STAFF RECOMMENDATION

321 South 16th Street

March 17, 2021

Application: New Construction—Addition; Setback Determination

Figure 1. 321 South 16th Street.

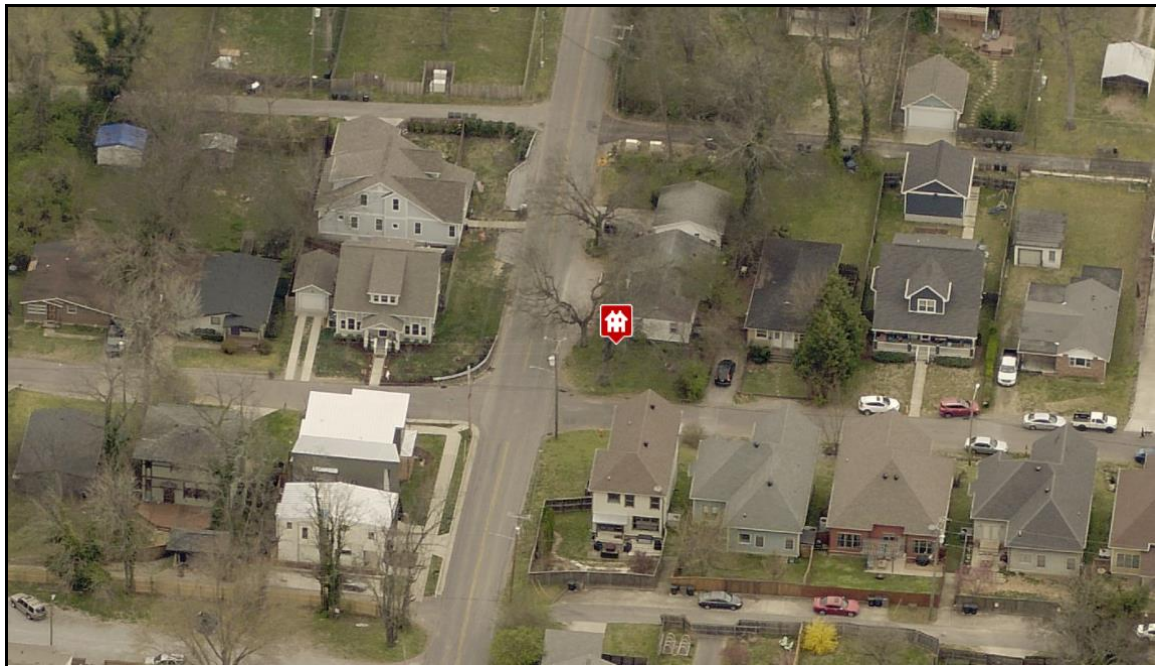
Background: The house located at 321 South 16th Street was constructed c. 1950 and does not contribute to the historic context of the Lockeland Springs-East End Neighborhood Zoning Overlay (Figure 1). The lot is oriented to Boscobel Street, but the building entrance is oriented to South 16th Street.

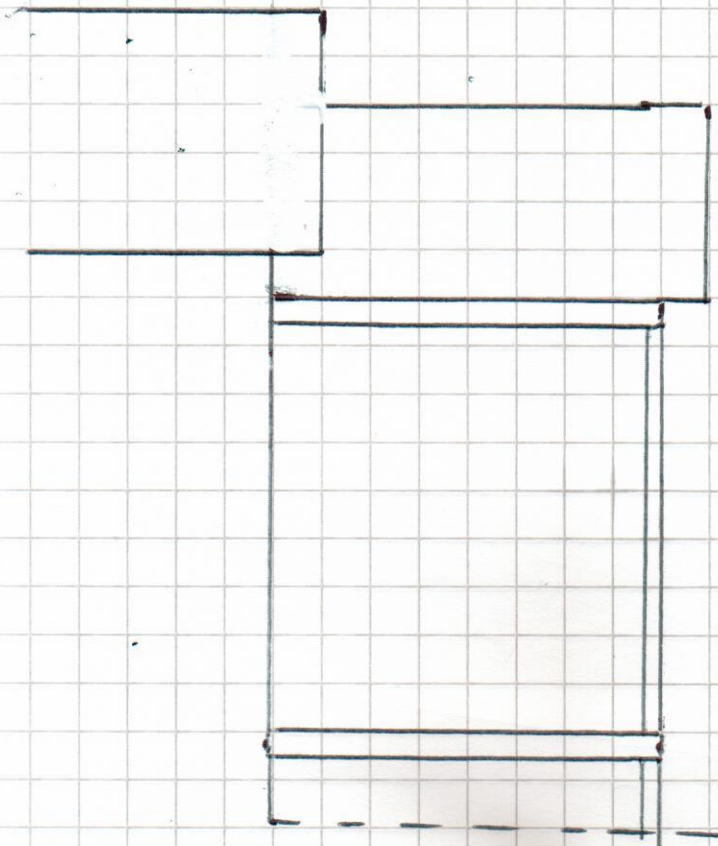
The proposed porch is located approximately twenty-five feet (25') from the Boscobel Street property line. The three houses to the right of the site as well as the house across South 16th Street are non-contributing. As proposed, the new construction would sit forward of the front wall of 1603 Boscobel Street as well as the front porch at 1605 Boscobel Street but would be approximately eleven feet (11') behind the front porch at 1523 Boscobel Street. Given the context, the proposed front setback could be appropriate for a front porch since it would create a transition between the adjacent front setbacks.

The applicant proposes to locate the covered deck seventeen feet (17') from South 16th Street. Staff finds that the proposed street setback could be appropriate since it is similar to the setback of the infill at 1523 Boscobel Street and a forty foot (40') setback would nearly impossible to meet on a fifty foot (50') wide lot.

While the proposed setbacks along both street frontages could be appropriate, staff finds that the design and materials are inappropriate for a front porch and, for this reason, finds that the project does not meet Section II.B.3.

Covered Porch
(side view)

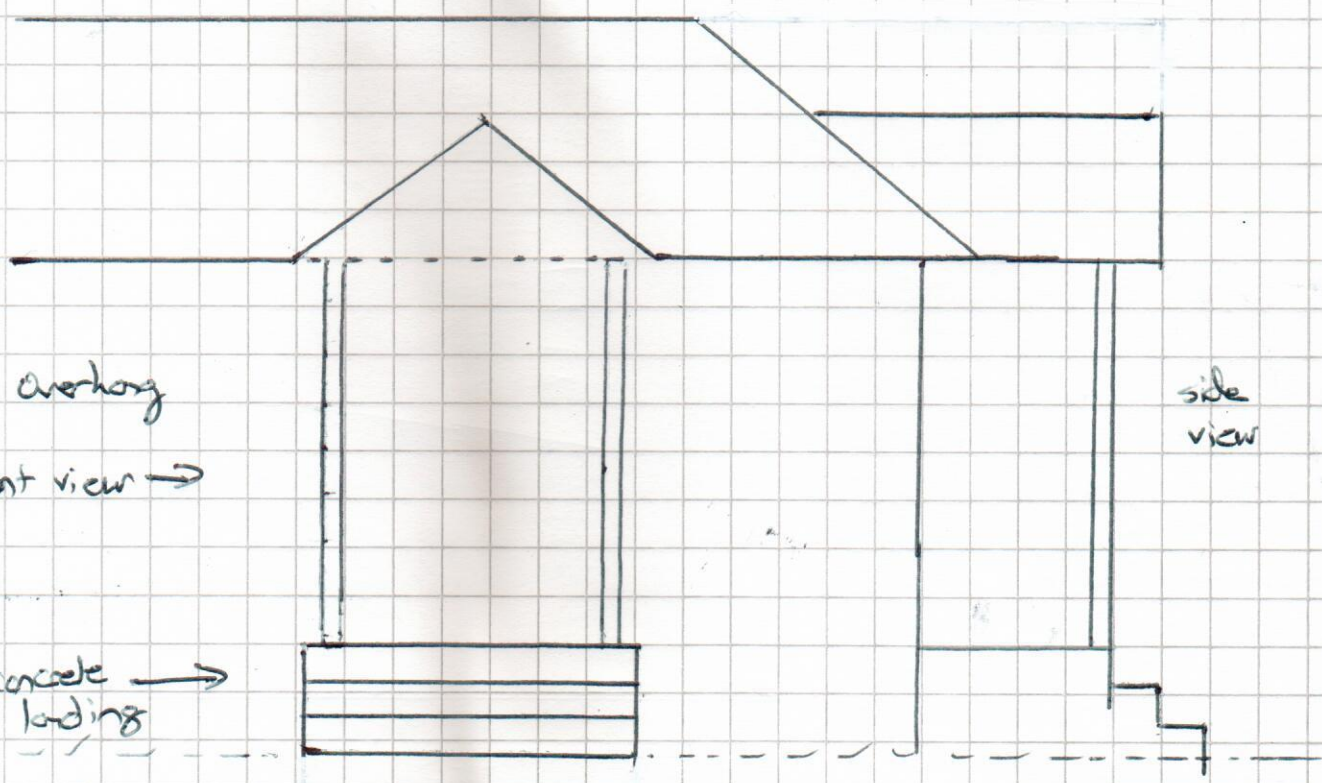
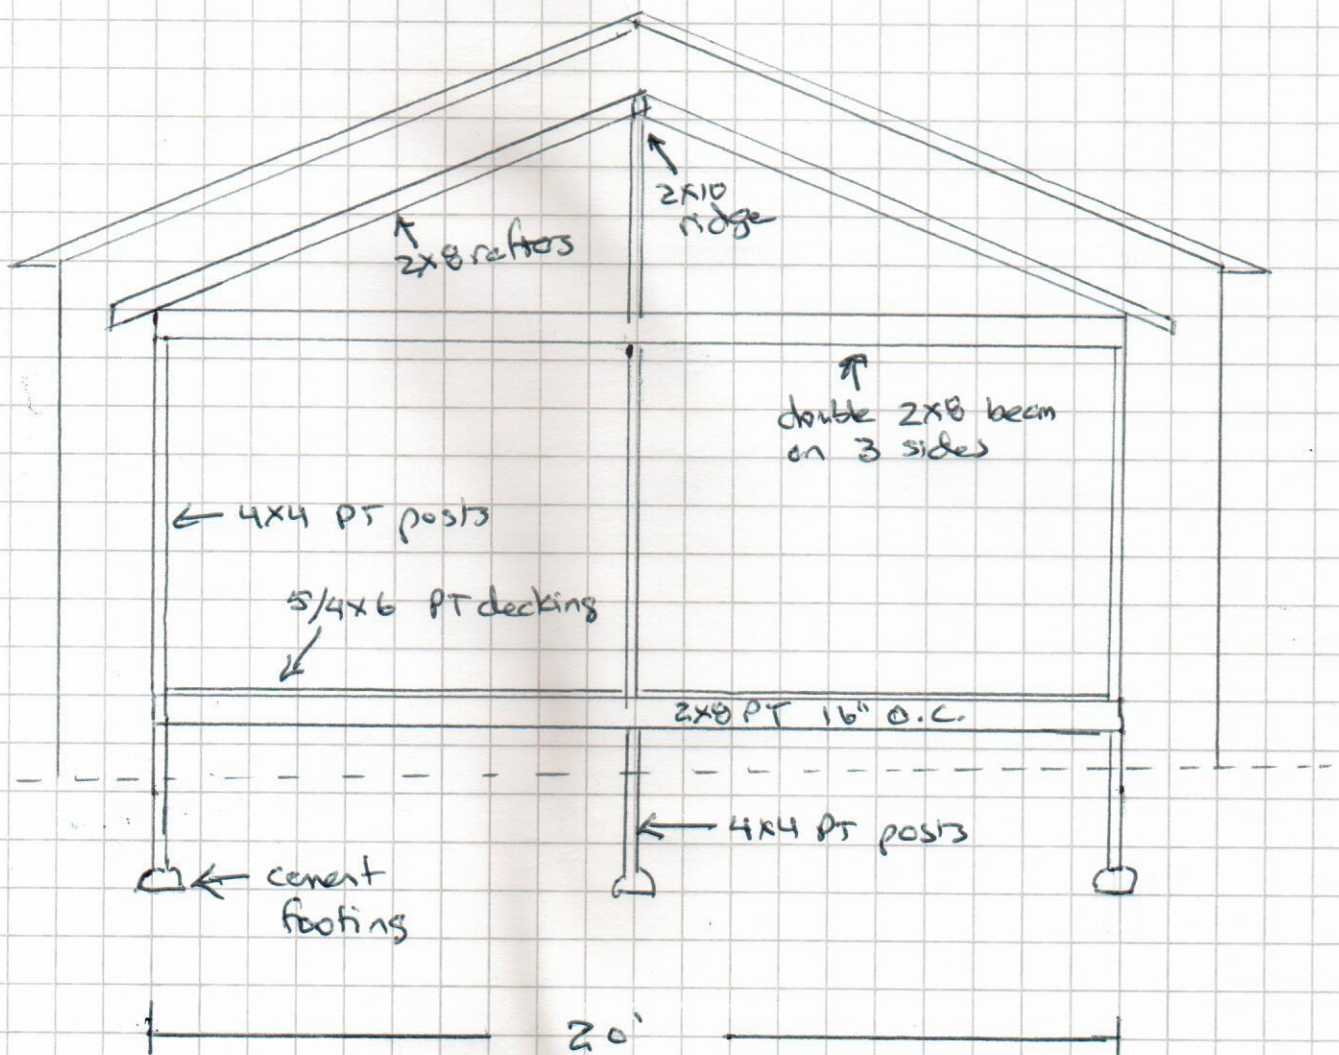
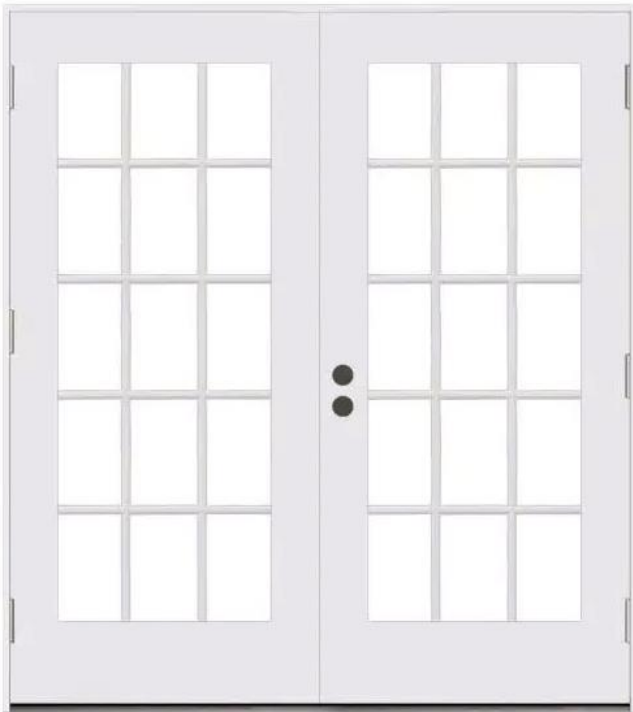
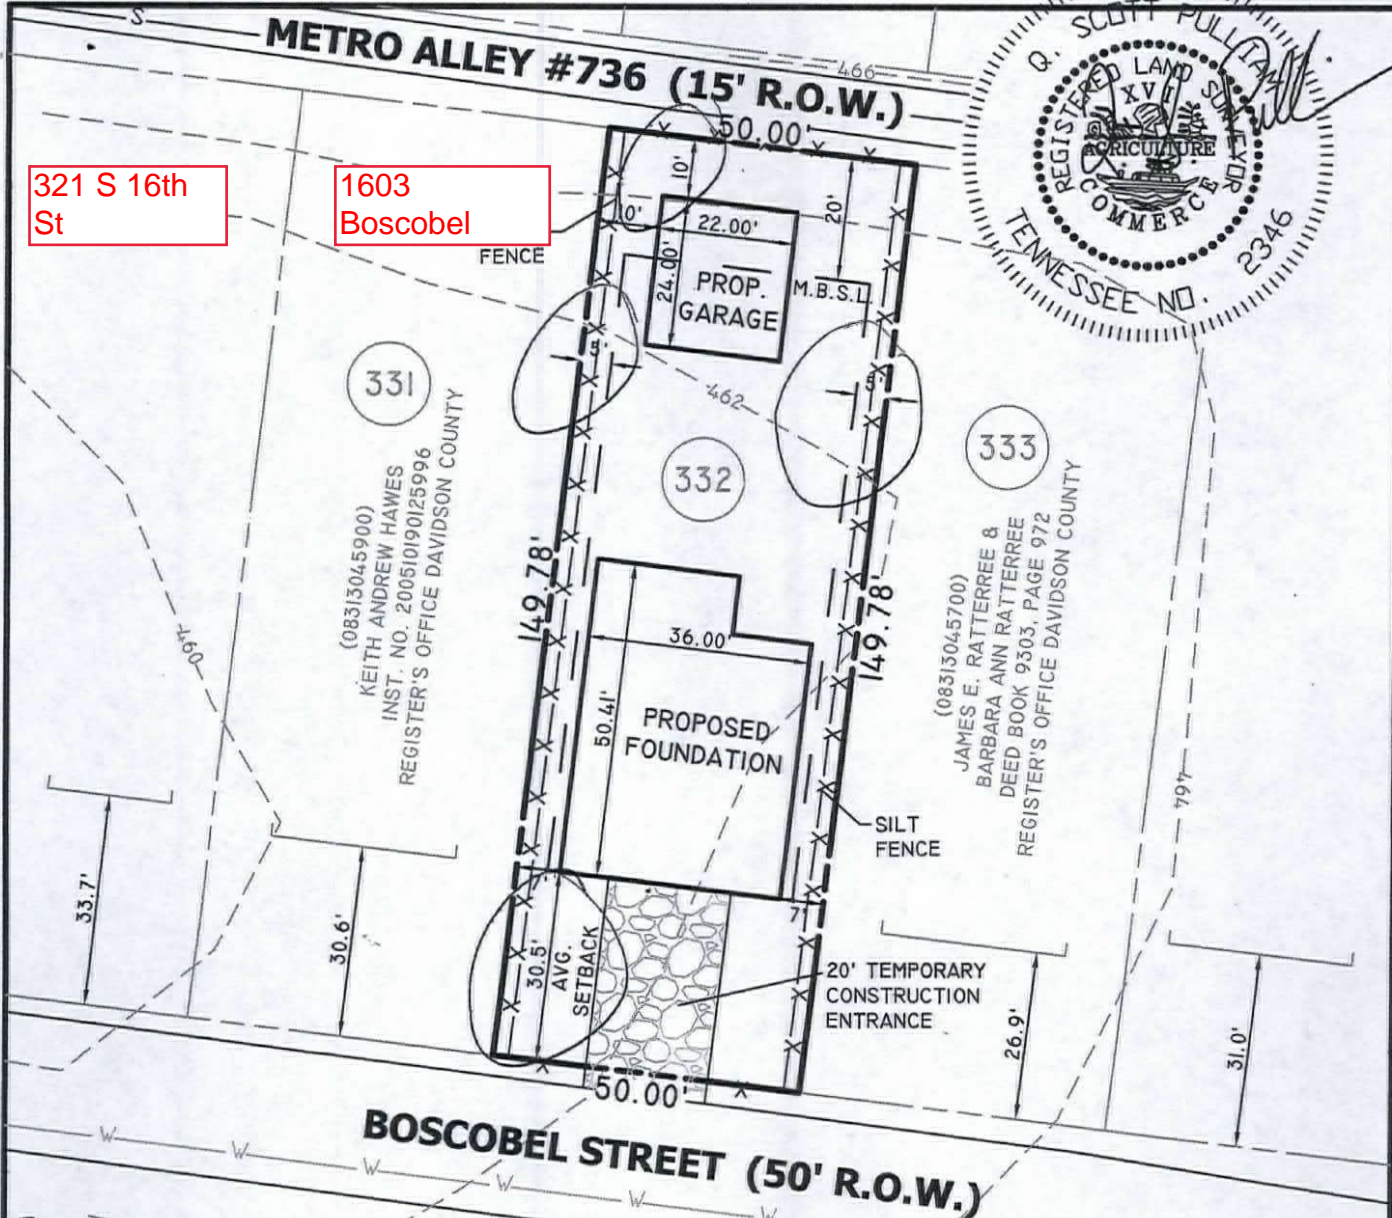
Design: The design of the addition is simple and typical for a covered porch but is not appropriate for a front porch addition. The addition does not include a foundation and or material in the gable field. While a front porch addition could be appropriate, covered decks are elements more suitable for rear or minimally visible side façades. A front porch that includes the design elements that are characteristic of a front porch such as a foundation, material in the gable field, appropriately scaled porch posts, and appropriate front door dimensions could move the site closer to meeting the design guidelines.

As proposed, the covered deck would be constructed of pressure treated wood on cement footings with an asphalt shingle roof. While these materials would be appropriate for a covered deck located in a rear or minimally visible side yard, they are not appropriate as proposed. In order to meet the design guidelines, new construction on the Boscobel Street façade should be more typical for a front porch, which includes a foundation, closed gable field, and appropriately scaled porch posts. The project does not meet Section II.B.4.
